Agenda Item # 2

SUB-002628-2023

Dean McCrary Subdivision

Subdivision approval to amend an existing legal lot of record by removing a note from the previously recorded plat.

SITE PLAN

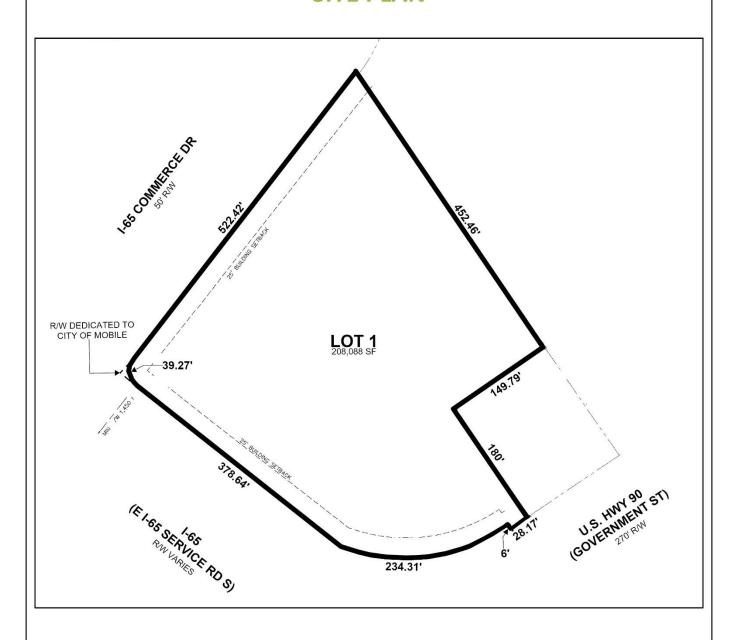
The purpose of this application is to amend the subdivision plat recorded in 2013 to remove a note, which states that the lot is limited to the existing curb-cut along East I-65 Service Road South. No changes to the existing lot lines are proposed.

The site has frontage on East I-65 Service Road South, an ALDOT-maintained street that services Interstate 65 and requires a 300-foot right-of-way. The site also has frontage on I-65 Commerce Drive, a minor street with curb and gutter requiring a 50-foot right-of-way. The preliminary plat illustrates sufficient right-of-way along I-65 Commerce Drive, but the preliminary plat depicts a varying right-of-way along the I-65 Service Road at this location. While GIS maps indicate there is adequate right-of-way, the plat should be revised to depict that there is sufficient right-of-way along East I-65 Service Road. No additional dedication should be required along I-65 Commerce Drive.

A 25-foot front yard setback is illustrated along all frontages on the preliminary plat, in compliance with Section 64-2-5.E. of the Unified Development Code (UDC). This information should be retained on the Final Plat, if approved.

- 1. Revision of the Final Plat to depict sufficient right-of-way along East I-65 Service Road South;
- 2. Retention of the lot size labels in both square feet and acres, or provision of a table on the Final Plat with the same information;
- 3. Retention of all setbacks as illustrated on the preliminary plat;
- 4. Compliance with all Engineering comments noted in this staff report;
- 5. Placement of a note on the Final Plat stating the Traffic Engineering comments noted in this staff report;
- 6. Compliance with all Urban Forestry comments noted in this staff report; and
- 7. Compliance with all Fire Department comments noted in this staff report.
